UNITED STATES DEPARTMENT OF COMMERCE United States Patent and Trademark Office Address: COMMISSIONER FOR PATENTS P.O. Box 1450 Alexandria, Virginia 22313-1450 www.uspto.gov

Application No.	Applicant(s)			
Office Action Summary		10/576,099	EVANS ET AL.			
		Examiner	Art Unit			
		ALEX W. MOK	2834			
	The MAILING DATE of this communication appears on the cover sheet with the correspondence address Period for Reply					
A SHORTENED STATUTORY PERIOD FOR REPLY IS SET TO EXPIRE 3 MONTH(S) OR THIRTY (30) DAYS, WHICHEVER IS LONGER, FROM THE MAILING DATE OF THIS COMMUNICATION. - Extensions of time may be available under the provisions of 37 CFR 1.136(a). In no event, however, may a reply be timely filed after SIX (6) MONTHS from the mailing date of this communication. - If NO period for reply is specified above, the maximum statutory period will apply and will expire SIX (6) MONTHS from the mailing date of this communication. - Failure to reply within the set or extended period for reply will, by statute, cause the application to become ABANDONED (35 U.S.C. § 133). Any reply received by the Office later than three months after the mailing date of this communication, even if timely filed, m

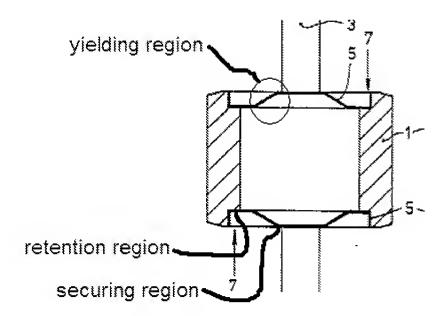
For claim 25, Weiland teaches each said at least one covering disk comprising a yielding region (see figure 1, and figure below).

For claim 26, the yielding region as explained for claim 25 above can constitute a bead extending in the circumferential direction.

For claims 30 and 31, the yielding region as disclosed by Weiland can be considered to be embodied as a connecting region, disposed between a securing region

and a retention region for the magnet element, and wherein the connecting region is inclined to the securing region (see figure above).

For claim 37, Weiland teaches each said at least one covering disk comprising a yielding region (see figure 1, and figure above).
